REPLY OF PREBID CLARIFICATION FOR SIDE STREAM FILTRATION PLANT FOR 1X800 MW KOTHAGUDEM TPS

**AMENDMENT ON TECHNICAL SPECIFICATION FOR SIDE STREAM FILTRATION PLANT
1X800 MW TSGENCO KOTHAGUDEM TPS, STAGE –VII, PALONCHA.**

SPECIFICATION NO.: PE-TS-410-181-A001

AMENDMENT NO # 1

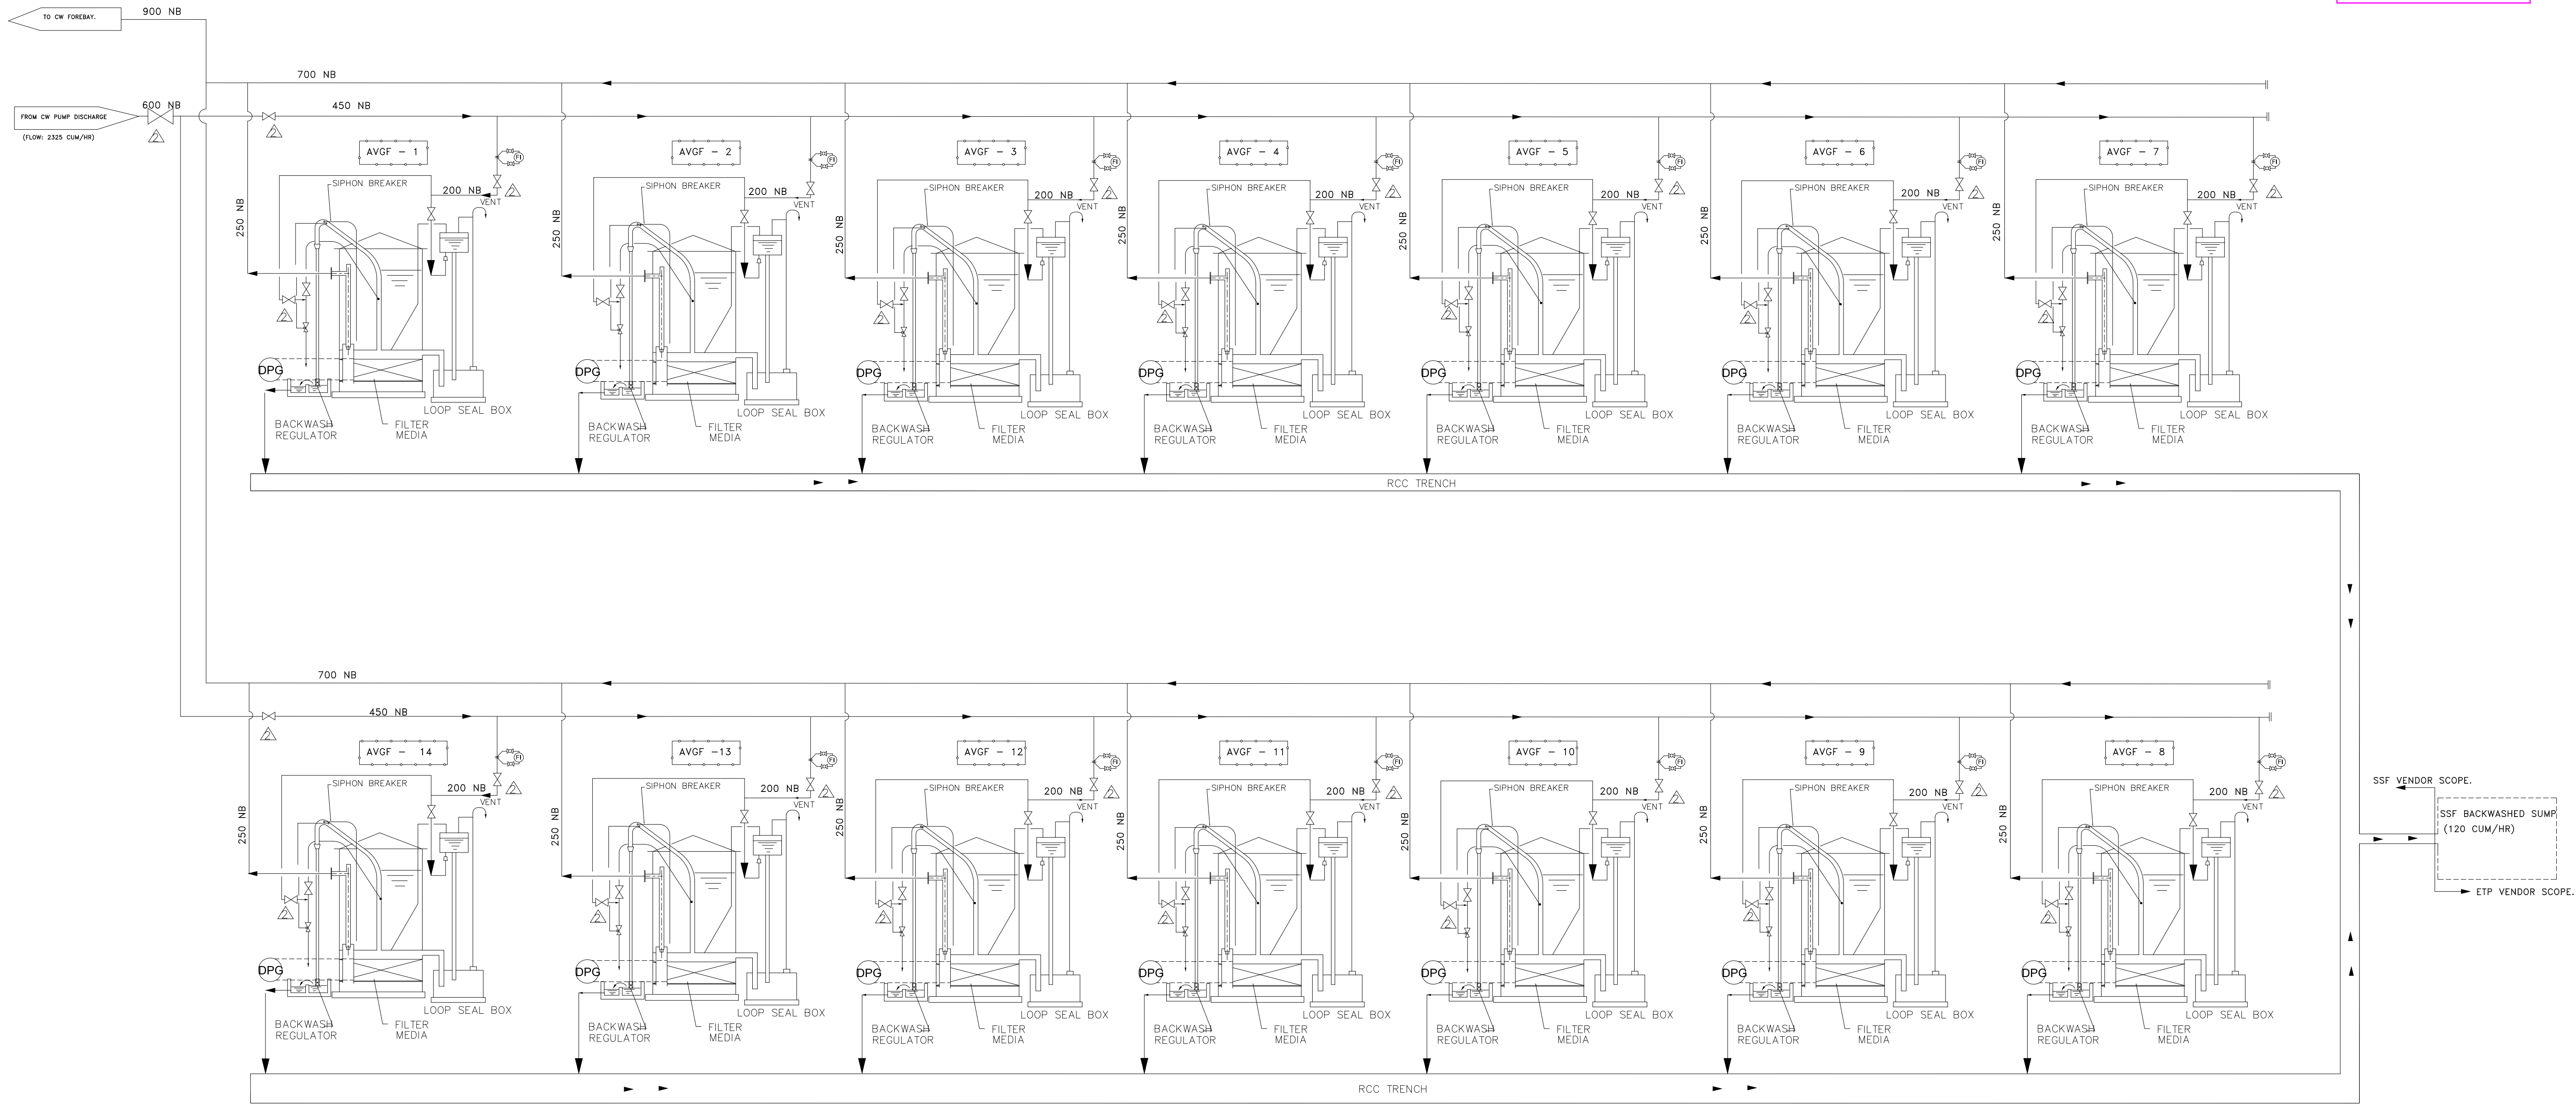
2.	IIB	SECTION– C	3.3	7 OF 59	Back Wash water outlet: Backwash water outlet piping till backwash sump (backwash sump is not in bidder's scope).	Back Wash water outlet: Backwash water outlet piping shall be terminated at common RCC trench passing near each filter as shown in P&ID –PE-DG-410-181-A001.

3.	IIB	SECTION– C	P&ID	36 OF 59	P&ID FOR SIDE STREAM FILTRATION PLANT (REV-1)	Refer Annexure-1 (P&ID): P&ID FOR SIDE STREAM FILTRATION PLANT (REV-2)
4.	IIB	SECTION– D	2.4	58 OF 59	Total lump sum price on performance guarantee test, and handing over to Purchaser the entire Side Stream Filtration Plant , as defined subsequently the Side Stream Filtration Plant and ancillaries as specified in Technical specification No. PE-TS-410-156-A001 as required for safe and trouble free smooth operation.	Total lump sum price on performance guarantee test, and handing over to Purchaser the entire Side Stream Filtration Plant, as defined subsequently the Side Stream Filtration Plant and ancillaries as specified in Technical Specification No. PE-TS-410-181-A001 as required for safe and trouble free smooth operation.
